**AGENDA
PLANNING AND ZONING COMMISSION
REGULAR MEETING
February 26, 2018**

Purpose: Conditional Expansion **Date:** 02/10/2018

Name of Plan: Farmer's Daughters

Purpose: Site Plan: Design Guidelines **Date:** 02/10/2018

3A-3

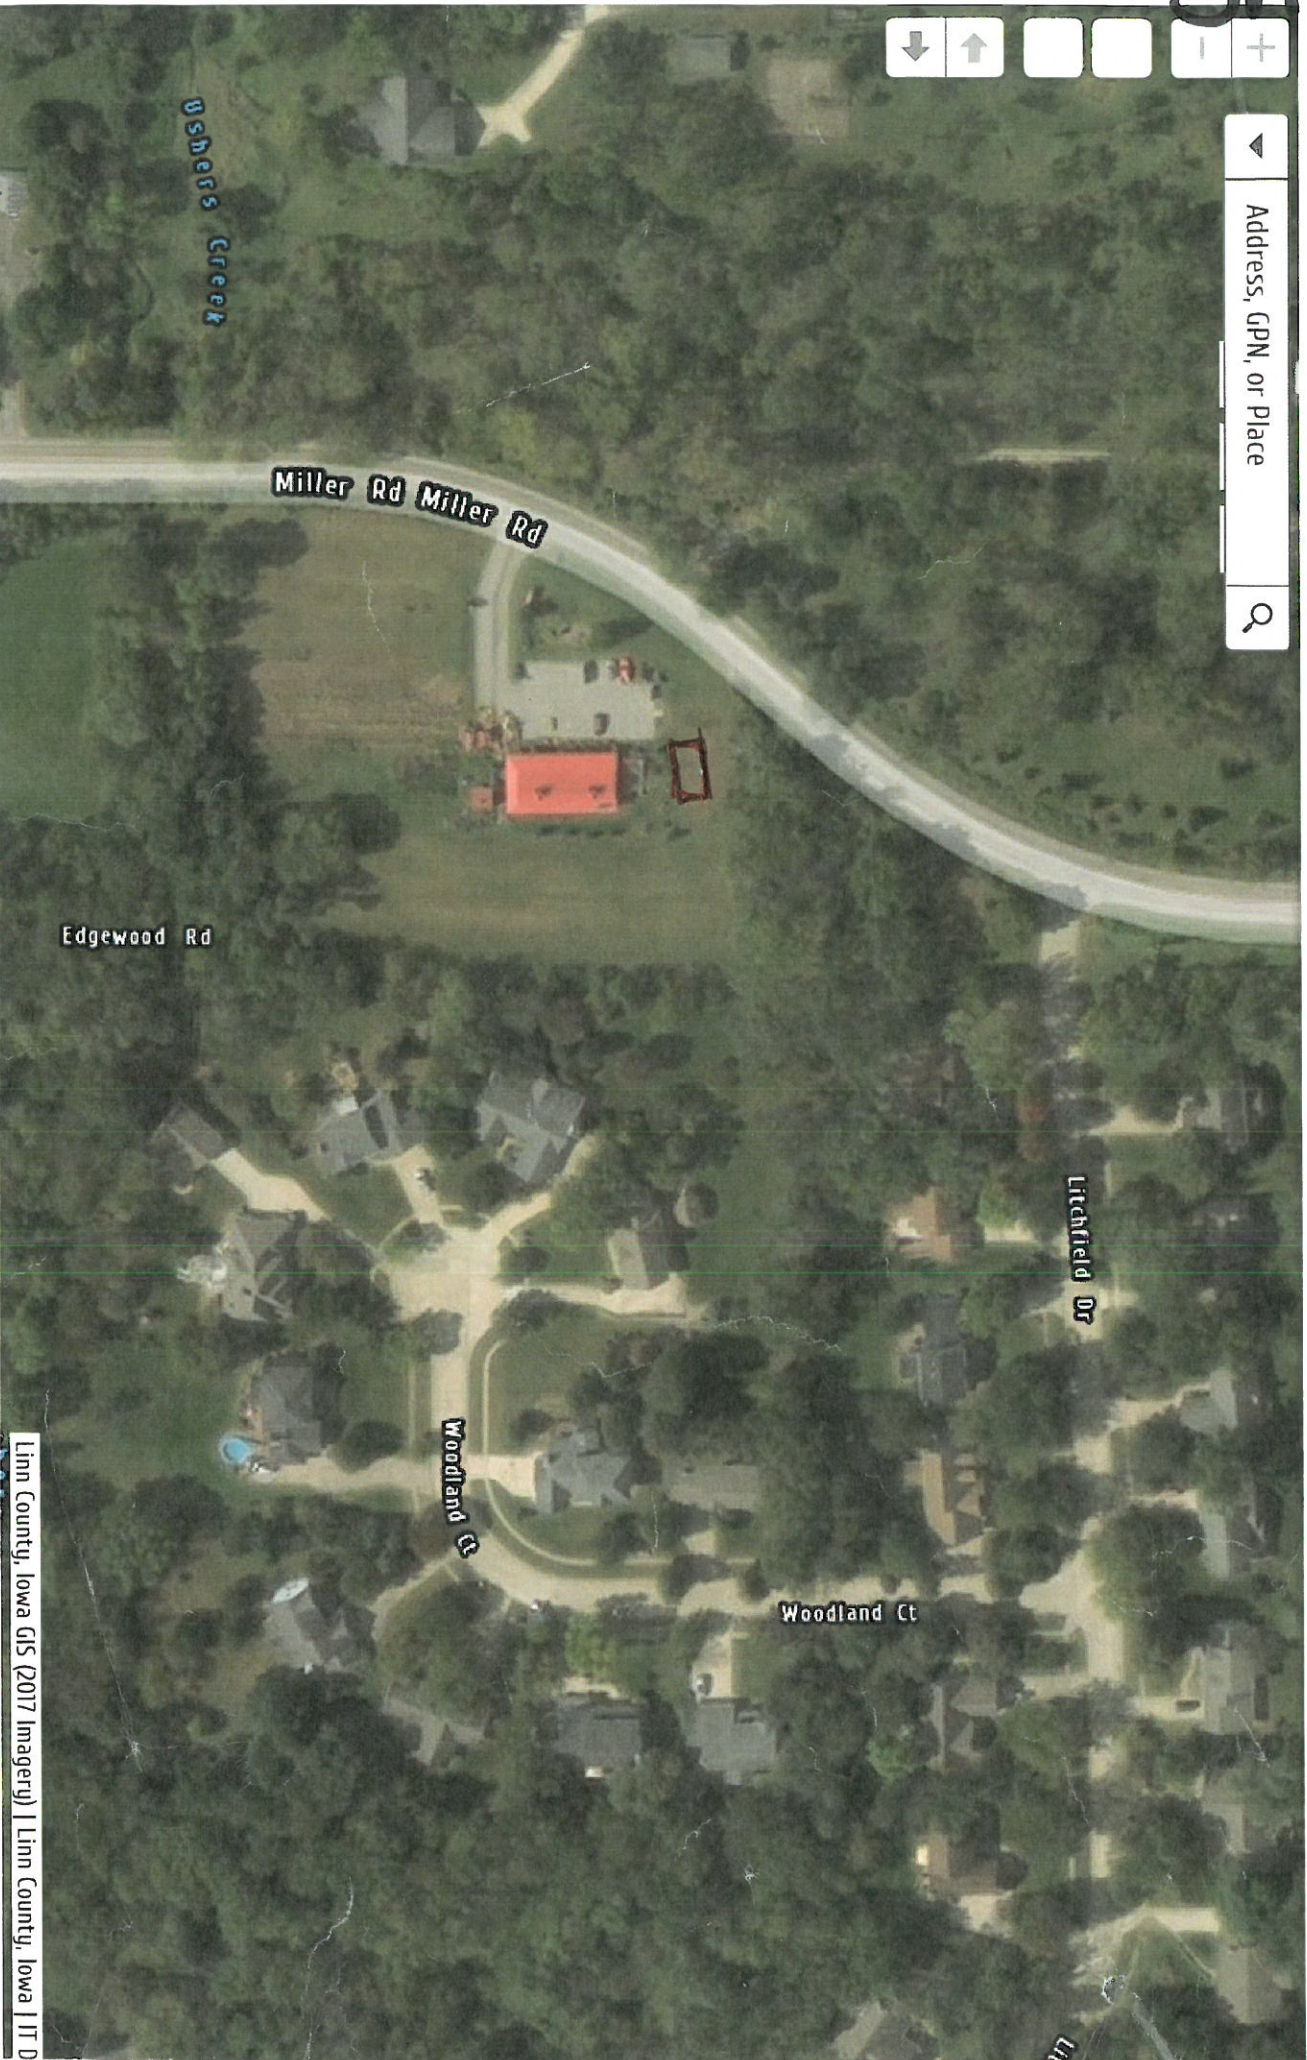
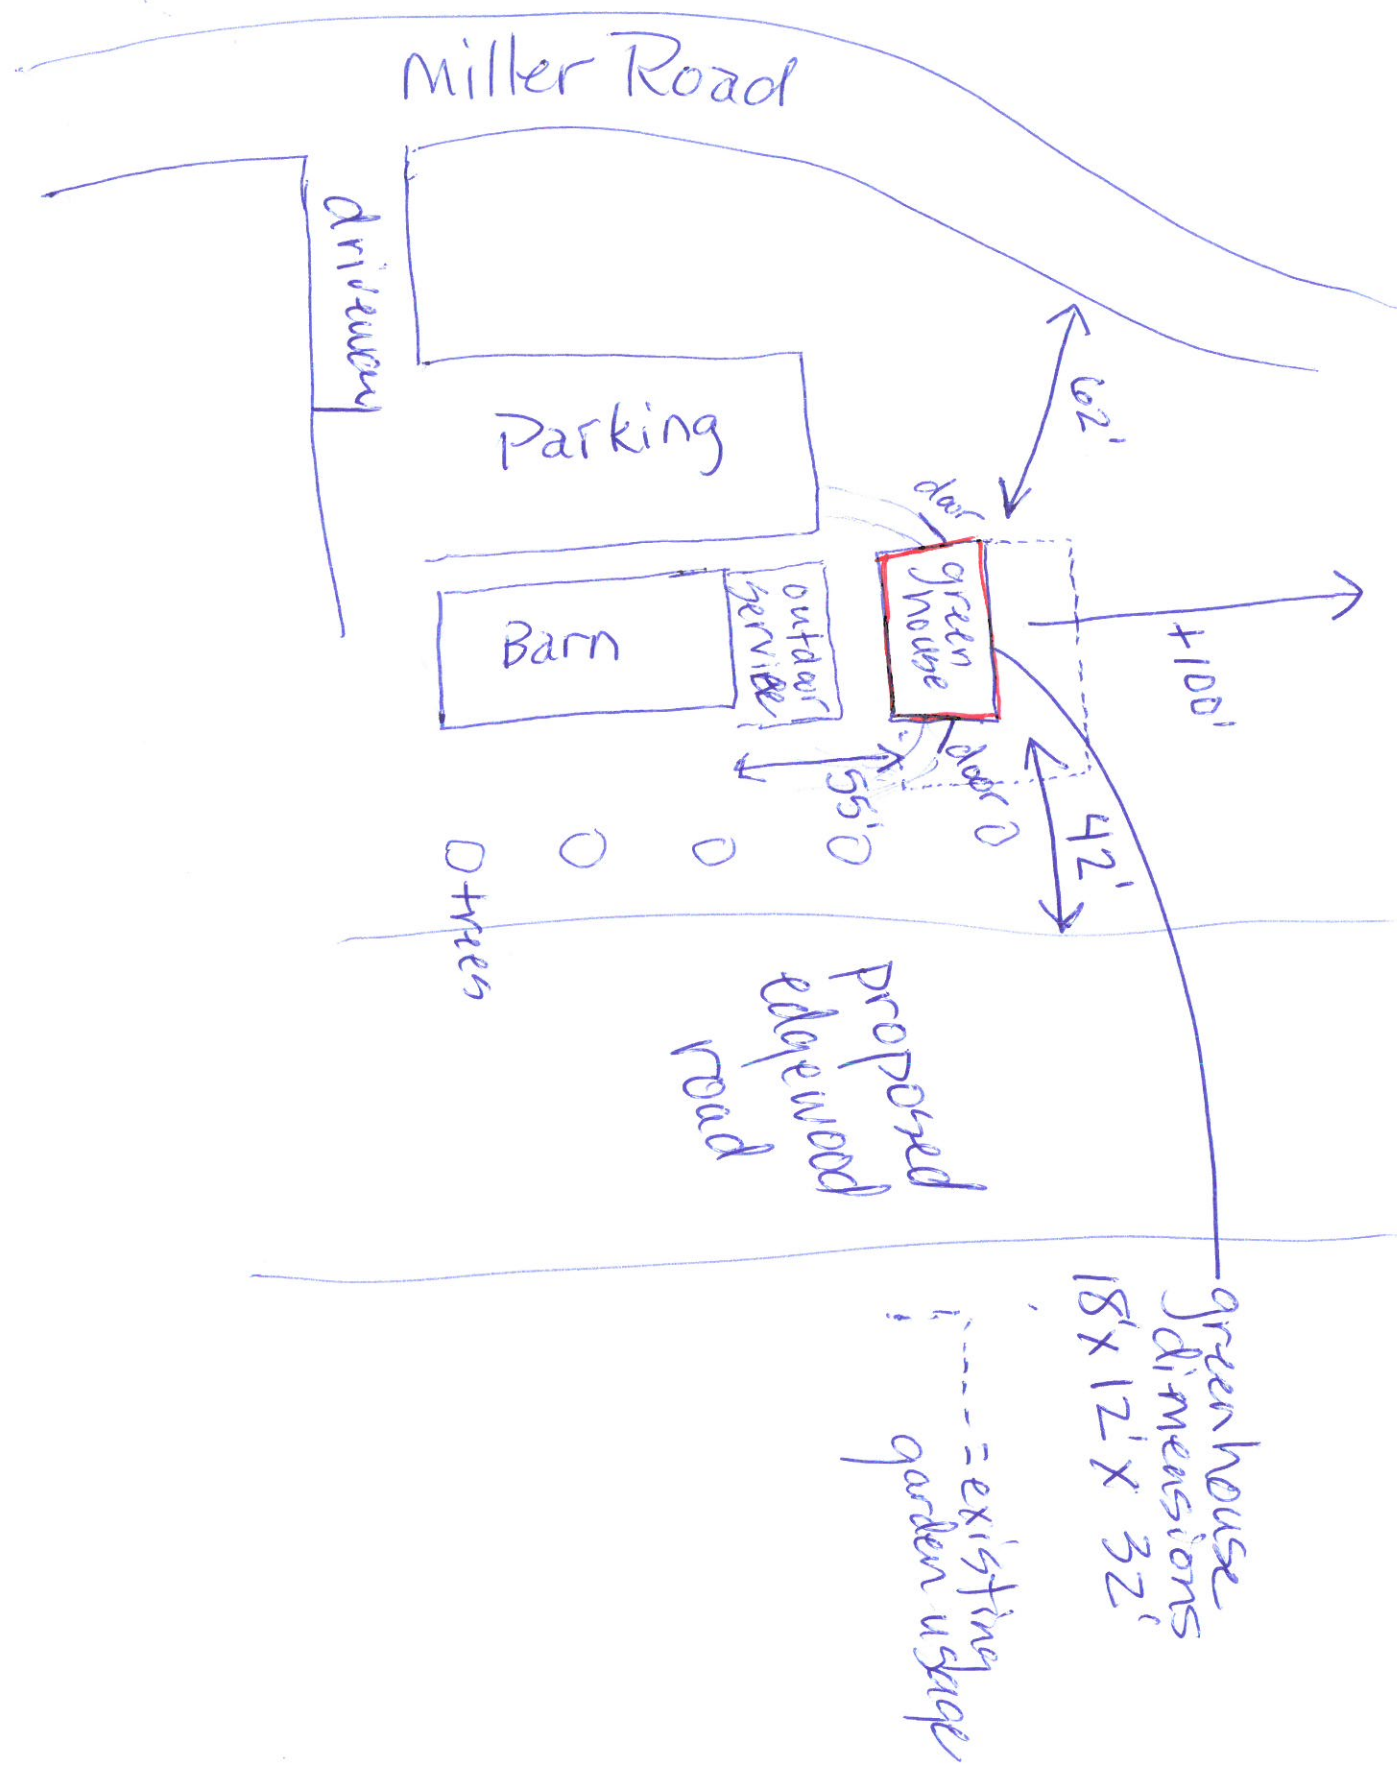
Report: The Planning and Zoning concern is with the expansion of a legal non-conforming use as provided in UDC Section 165.84. Paragraph 2(A) of this section permits this expansion which is a commercial use located in a commercial zone as long as the applicable setbacks are in compliance.

The site plan indicates the building can be located within the required setbacks however the plan does not coincide with estimated measurements from the Linn County mapping program. Actual lot lines must be established to verify the complying location of the greenhouse.

The proposed greenhouse may generate additional seasonal traffic because it will extend the availability of produce for sale. There have been no reports of traffic or parking problems with the present business. However, not all spaces are currently used for vehicle parking. We recommend maintaining all present parking for customer and employee parking since this expansion is minor and would only require a single additional space.

The existing use has not created an issue with the neighborhood except for temporary signage which encroaches onto the ROW. A condition to consider for this expansion is compliance with the temporary signage provisions in our Sign Code Chapter 166. Our sign code limits the

This zone requires that all activities and storage be located within buildings. The UDC does not allow outdoor sales and/or displays in C-2 zones. The present use includes outdoor storage, displays and sales. Conditions could be added restricting these activities or requiring screening along the developed ROW. Staff would recommend:

1. Require screening in accordance with 165.23 (9)D7 for all storage within view along Miller Road at this time and along Edgewood when developed.
2. Maintaining all displays in accordance with 165.23 (9)D8. This will require the removal of all displays from non-paved areas when the business is closed.
3. Allow the outside sales to continue as part of the existing legal non-conforming usage.

1. Property lines are verified for setbacks of 25 feet from the greenhouse to ROW.
2. Existing parking spaces are maintained for parking purposes only.
3. All temporary signage complies with the Sign Code chapter 166:
 - a. Signs must be located on the property
 - b. Signage is limited to an aggregate area of 32 square feet
 - c. Signs must not be displayed more than 75 days in a calendar year
4. All outside storage is removed or properly screened from view along all developed right of ways. The required ROW currently includes Miller Road and in the future Edgewood Road.
5. All outdoor displays comply with the UDC 165.23.
 - a. Displays shall not be on the ROW
 - b. Displays not on a hard surface are permitted only during business hours
6. The greenhouse is engineered, permitted and inspected in accordance with the fire code and building code.
